HISTORIC AND DESIGN REVIEW COMMISSION

June 05, 2019

HDRC CASE NO: 2019-169
ADDRESS: 314 E ROSEWOOD AVE
LEGAL DESCRIPTION: NCB 6728 BLK 4 LOT 35, 36 AND 37
ZONING: MF-33,H
CITY COUNCIL DIST.: 1
DISTRICT: Monte Vista Historic District
APPLICANT: Gordon Lee/Exxell Exxteriors
OWNER: Michael White
TYPE OF WORK: Construction of two, 1-story rear accessory structures
APPLICATION RECEIVED: May 17, 2019
60-DAY REVIEW: July 16, 2019
CASE MANAGER: Stephanie Phillips
REQUEST:

SCALE: 1/8" = 1'-0"

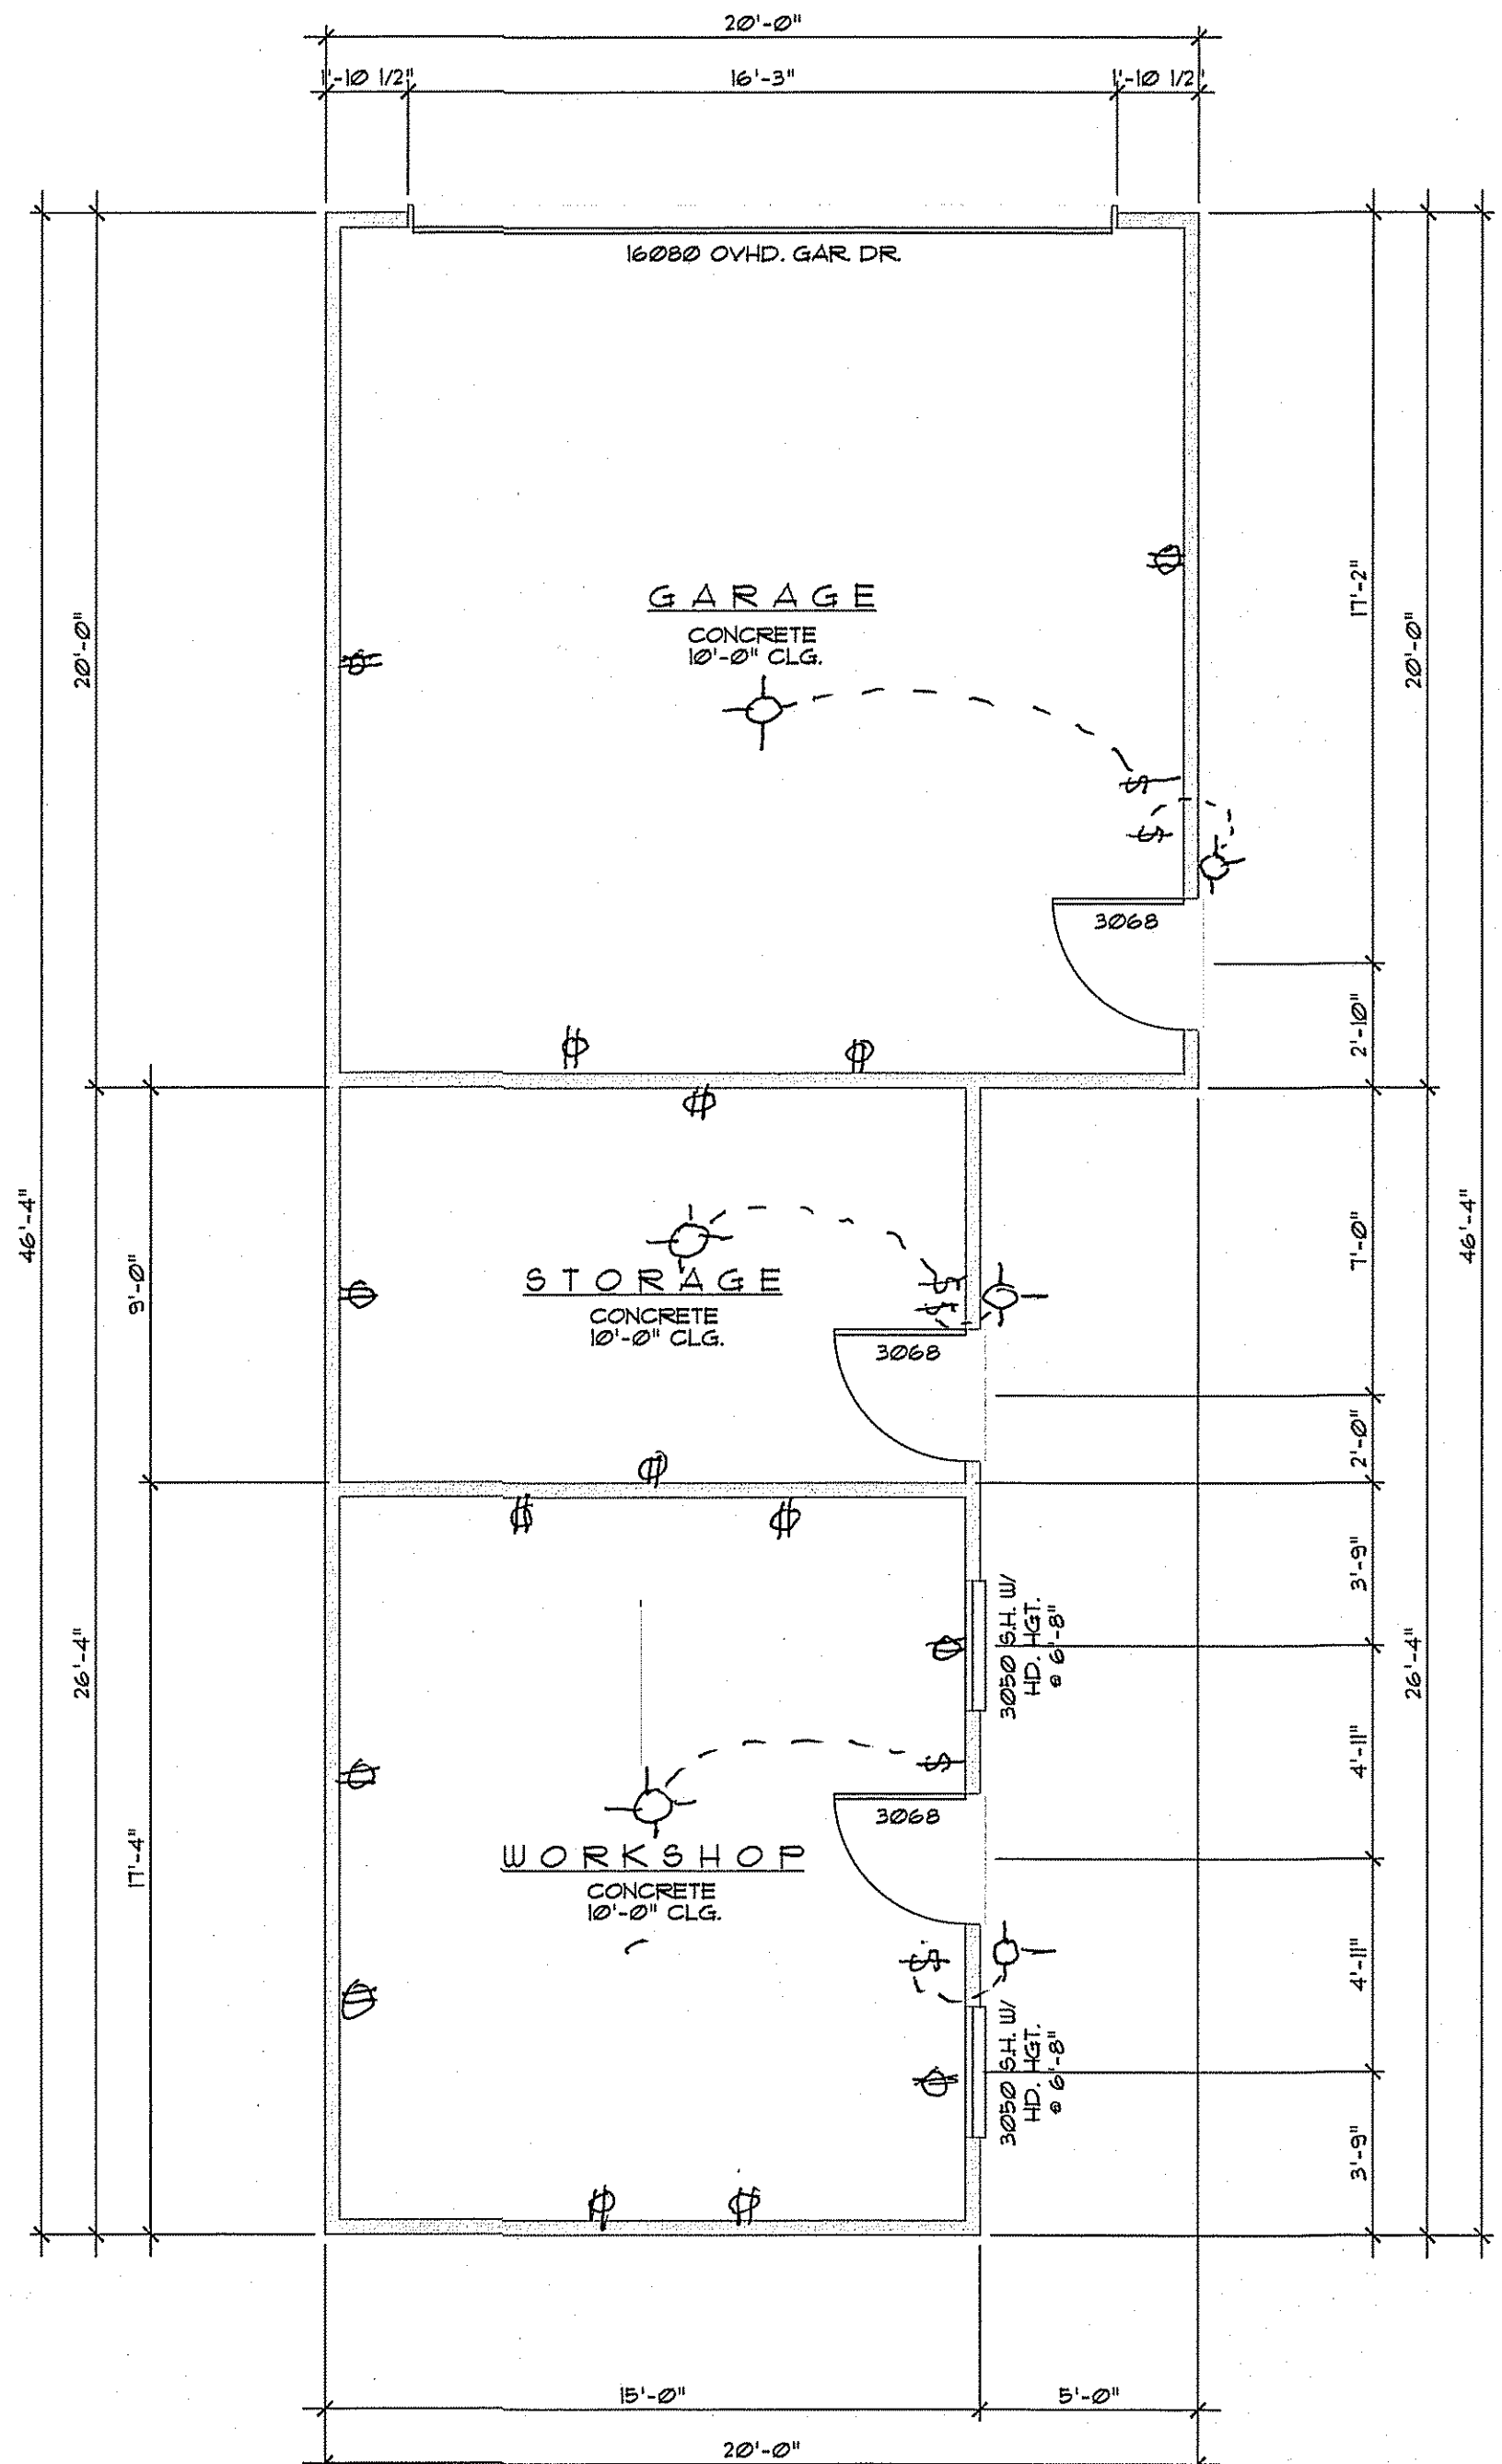
- e. GARAGE: SCALE & MASS – The applicant has proposed a 1-story garage structure with a gable roof. The structure will measure approximately fifteen feet in height. The Historic Design Guidelines state that new construction should be consistent with the height and overall scale of nearby historic buildings and rear accessory structures. The scale of the proposed structure does not impact or visually compete with primary structure on the lot or nearby historic structures, and will visually match the height of other garage structures along E Hollywood Ave. Staff finds the proposal consistent with the Guidelines.

- f. GARAGE: ROOF – The applicant has proposed a gable roof form for the structure. The roof will be constructed of shingles to closely match the materiality of the primary structure. Staff finds the proposal appropriate.

- g. GARAGE: MATERIALS –The Guidelines for New Construction state that materials should complement the type, color, and texture of those found in the historic district. The primary façade materials are not indicated in the application. The applicant has indicated that an existing non-original stone wall will be reused to frame the sides of the garage and that additional stone will be used to partially reconstruct the wall in a different location. Staff generally finds this approach consistent.

- h. GARAGE: FENESTRATION – The applicant has proposed several openings on the proposed garage structure, including an overhead garage door facing E Hollywood Ave and several openings on the west façade towards the interior of the lot. The openings appear to be generally proportionate and consistent with the Guidelines. While the long blank facade on the east (left) elevation is generally discouraged, staff finds that the proposed elevation's location immediately adjacent to a privacy fence presents a condition where a lack of fenestration will not detract from the surrounding conditions or the district. Staff finds the fenestration acceptable given these site-specific conditions.

- i. GARAGE: ARCHITECTURAL DETAILS – Generally, new buildings in historic districts should be designed to reflect their time while representing the historic context of the district. Architectural details should also not visually compete with the historic structure. While staff finds the roof form and general scale to be appropriate, staff finds that the structure should establish a stronger visual language with the primary historic structure and existing accessory structure on site through architectural details. Staff recommends that the applicant incorporate gable vergeboarding detail or similar elements pulled from the primary structure to strengthen this connection.

- i. That the applicant incorporates gable vergeboarding detail or similar architectural elements into the garage design as noted in finding i. The applicant is required to submit final elevations, plans, and design details to staff for review and approval prior to obtaining a Certificate of Appropriateness.

- ii. That the applicant provides final door and window specifications for final approval. The doors should be wood and the windows should meet the following stipulations: Meeting rails must be no taller than 1.25” and stiles no wider than 2.25”. There should be a minimum of two inches in depth between the front face of the window trim and the front face of the top window sash. This must be accomplished by recessing the window sufficiently within the opening or with the installation of additional window trim to add thickness. Window trim must feature traditional dimensions and architecturally appropriate sill detail. Window track components must be painted to match the window trim or concealed by a wood window screen set within the opening.

A-2
OF 2

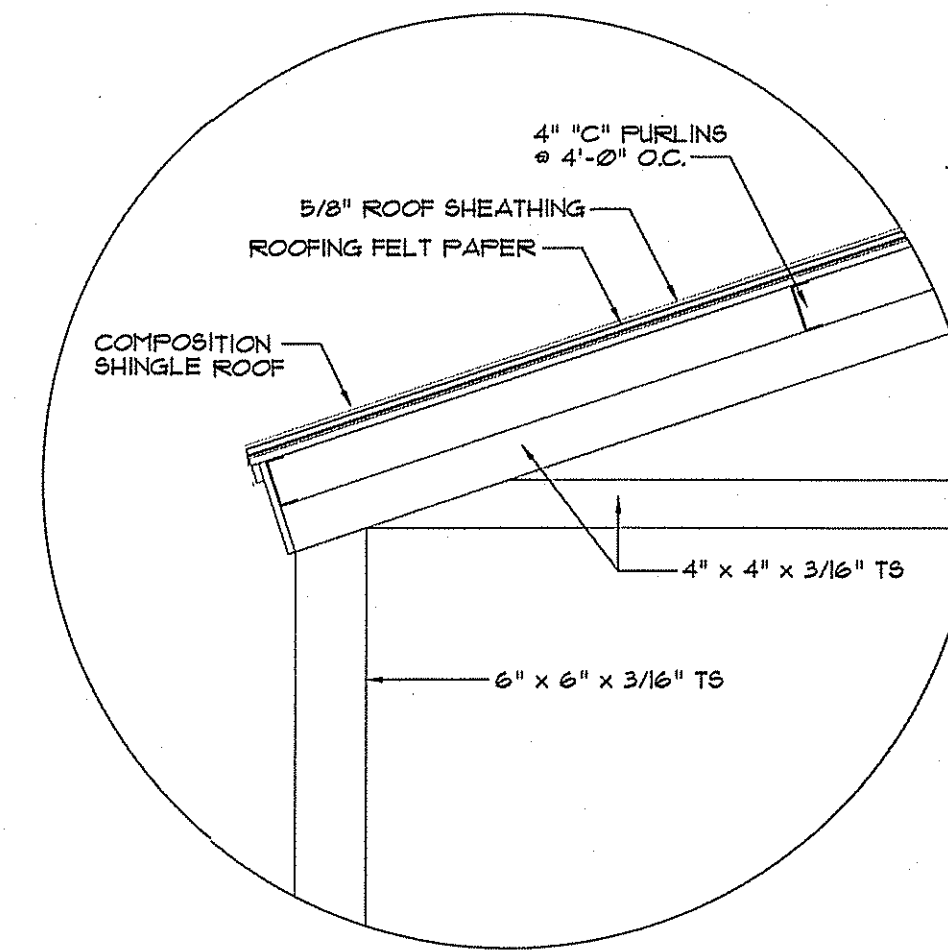
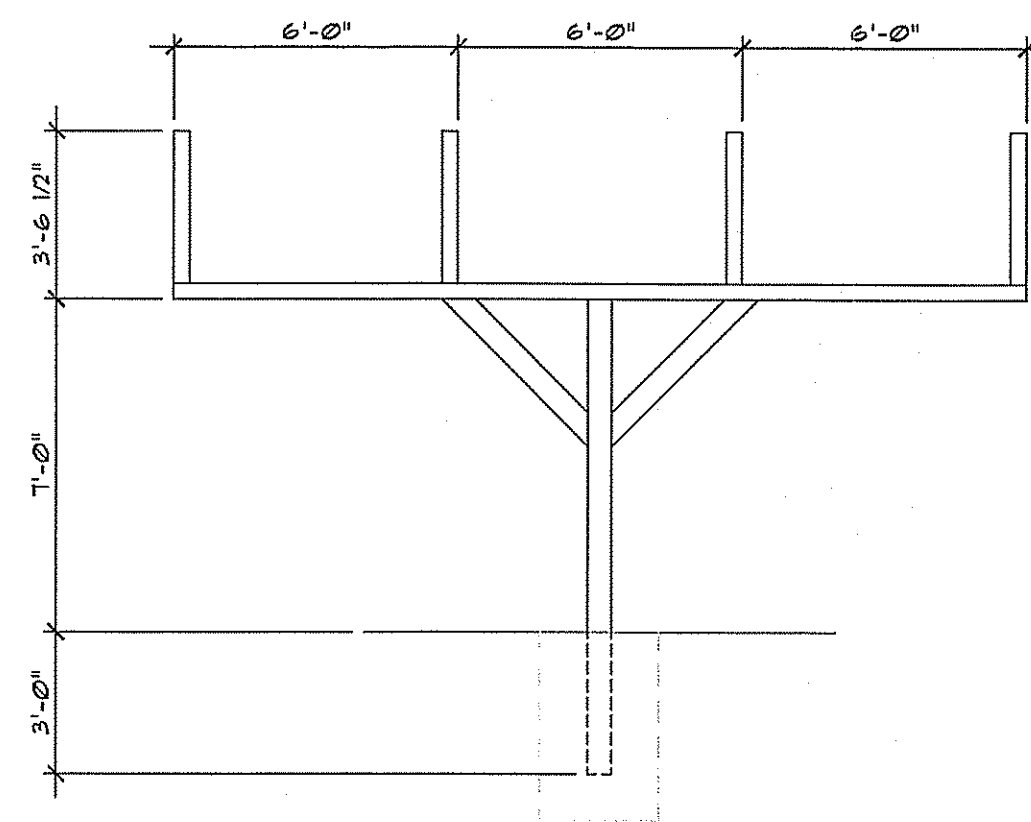
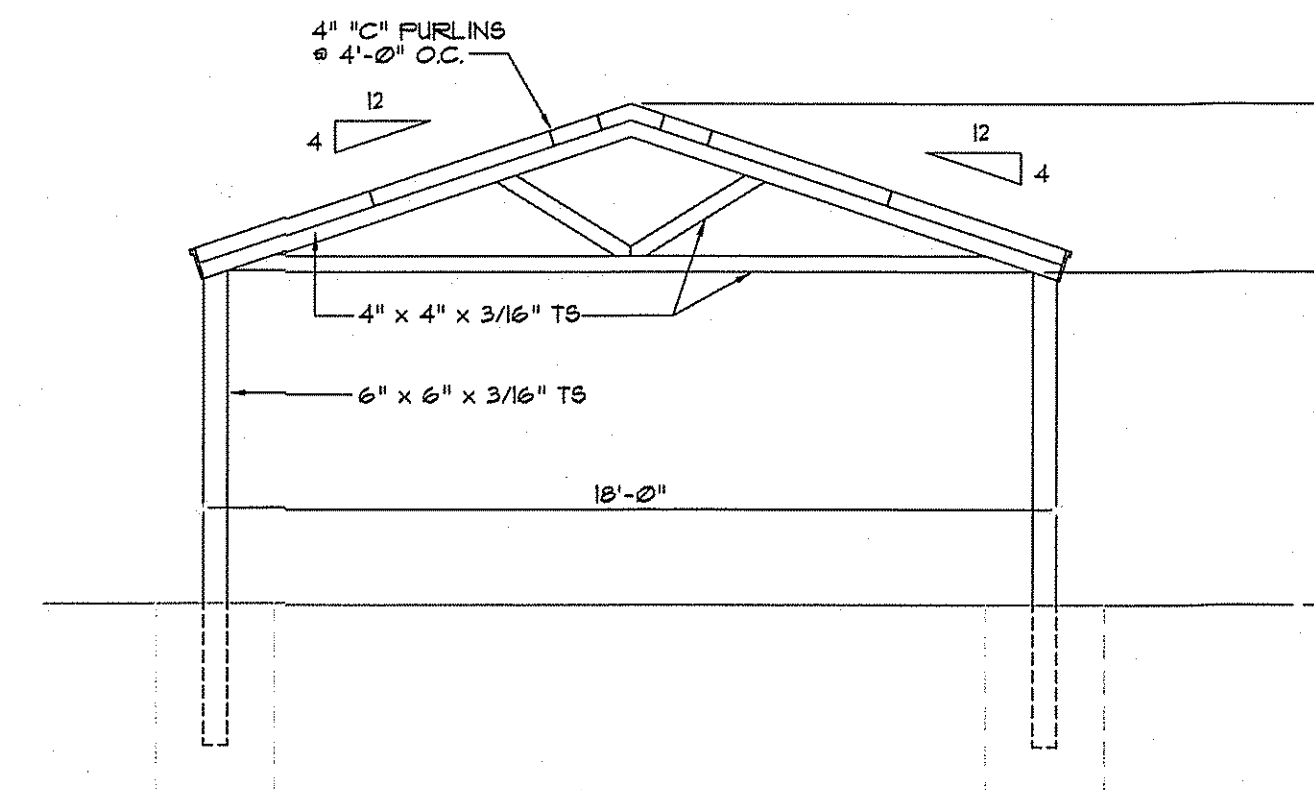
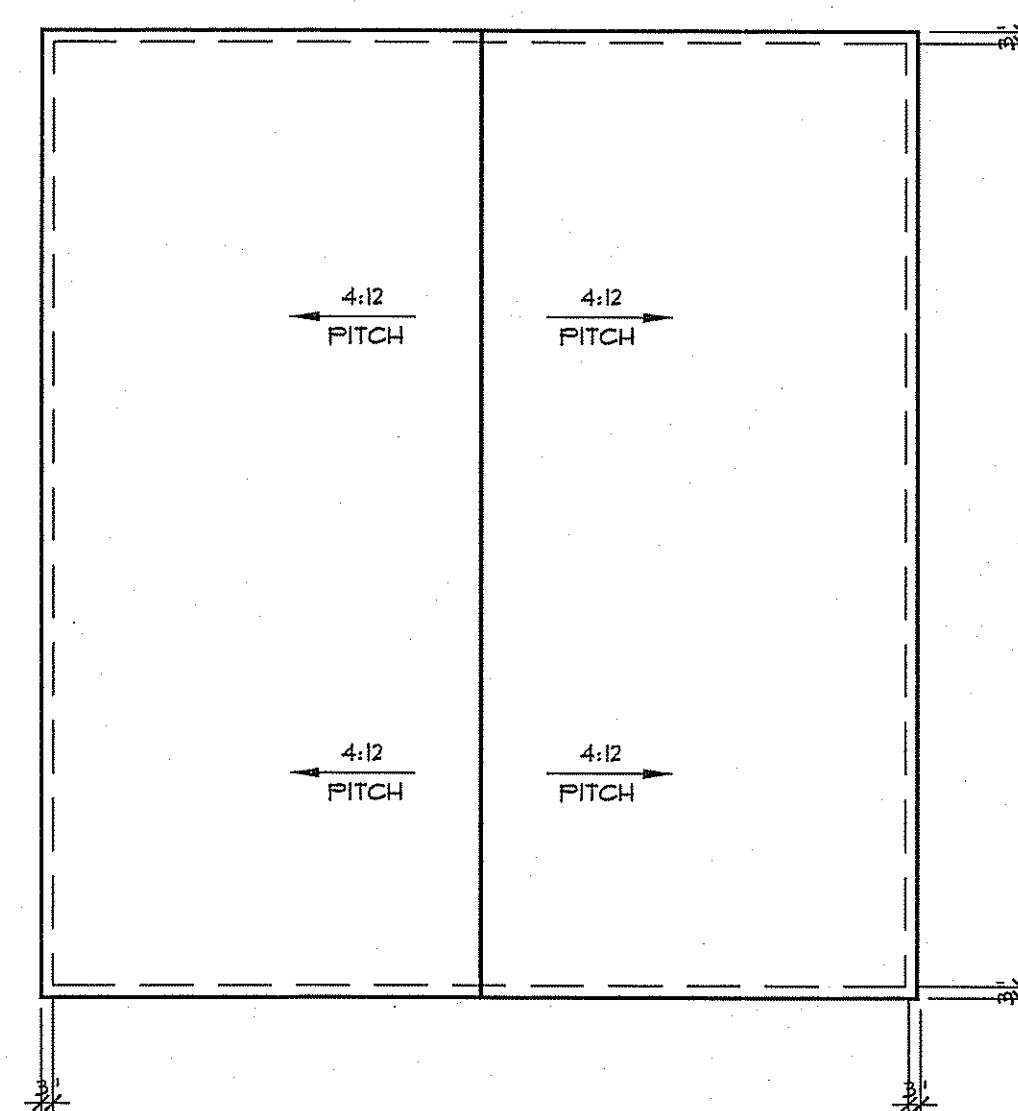
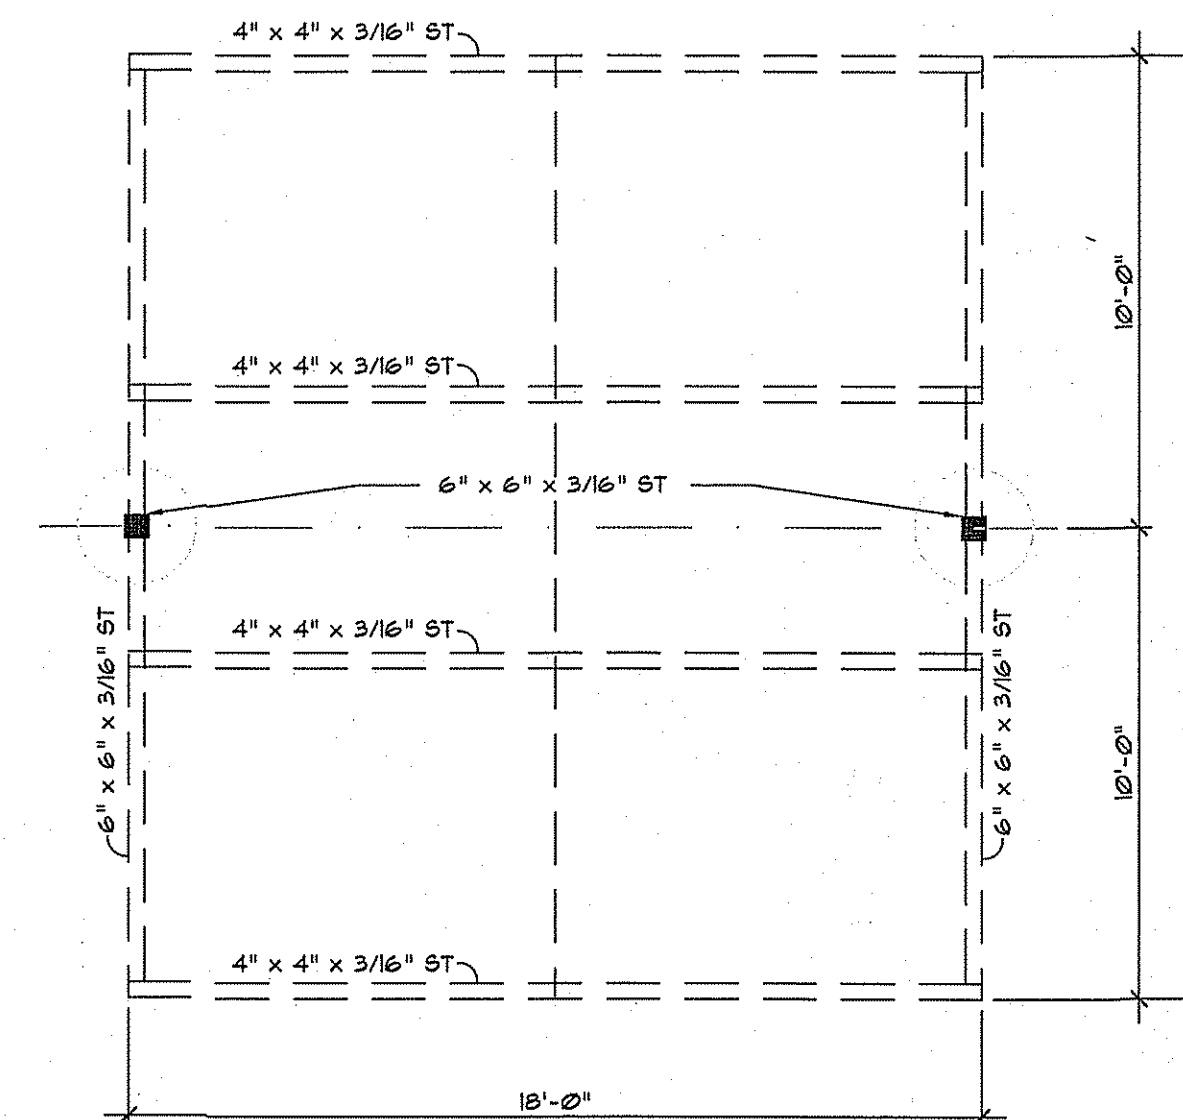
- l. CARPORT: SCALE & MASS – The applicant has proposed a 1-story carport structure with a gable roof. The structure will measure approximately fifteen feet in height. The Historic Design Guidelines state that new construction should be consistent with the height and overall scale of nearby historic buildings and rear accessory structures. The scale of the proposed structure does not impact or visually compete with primary structure on the lot or nearby historic structures, and will visually match the height of other garage structures along E Hollywood Ave. Staff finds the proposal consistent with the Guidelines.

- m. CARPORT: ROOF – The applicant has proposed a gable roof form for the structure with a decorative gable detail. The roof will be constructed of shingles to closely match the materiality of the primary structure. Staff finds the proposal appropriate.

- n. CARPORT: MATERIALS –The Guidelines for New Construction state that materials should complement the type, color, and texture of those found in the historic district. The primary façade materials are not indicated in the application. Staff requires all material information for final approval.

- o. CARPORT: ARCHITECTURAL DETAILS – Generally, new buildings in historic districts should be designed to reflect their time while representing the historic context of the district. Architectural details should also not visually compete with the historic structure. Staff finds that the vergeboarding detail on the carport to be appropriate.
